Title: BRIEFING ON STAFF COMMENTS ON DOE SITE
CHARACTERIZATION PLAN FOR YUCCA MOUNTAIN

Date: JULY 11, 1989

COMMISSION BRIEFING
ON THE
NRC REVIEW OF
THE DOE
SITE CHARACTERIZATION PLAN
FOR YUCCA MOUNTAIN
NYE COUNTY, NEVADA
JULY 11, 1989

Figure 1-40. Faults and fractures at Yucca Mountain interpreted from electrical resistivity data. Stippling shows zone of inferred fracturing and faulting along Drill Hole Wash; fault trends appear to change abruptly across this zone. Modified from USGS (1984).

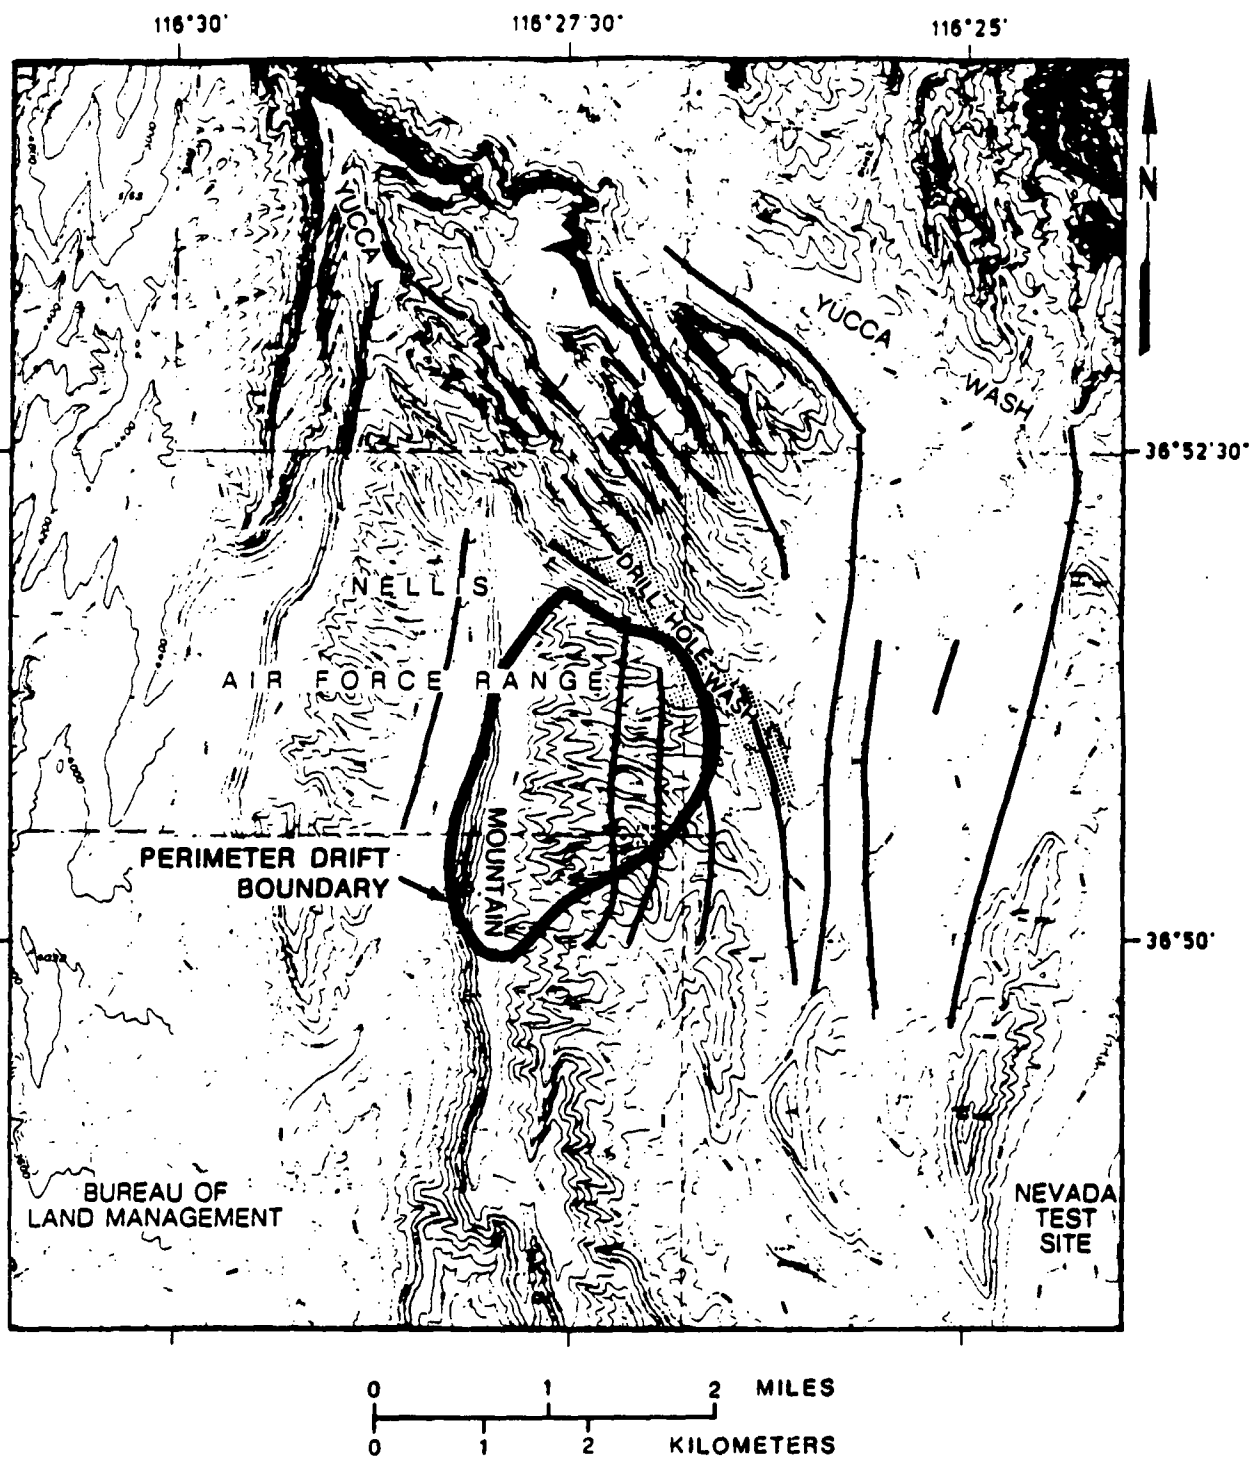
17 Now, they are already working, and the next
18 figure, page 9, is a map that you may have seen before
19 from the site characterization plan and from
20 correspondence related to the case. DOE is already
21 working at the site on the geologic anomaly or fault.
22 If you look at the circle -- not a circle but sort of
23 an ellipse of this site boundary and you see three
24 vertical lines, the center line is what some people
25 call the no name fault. It's a geological anomaly.
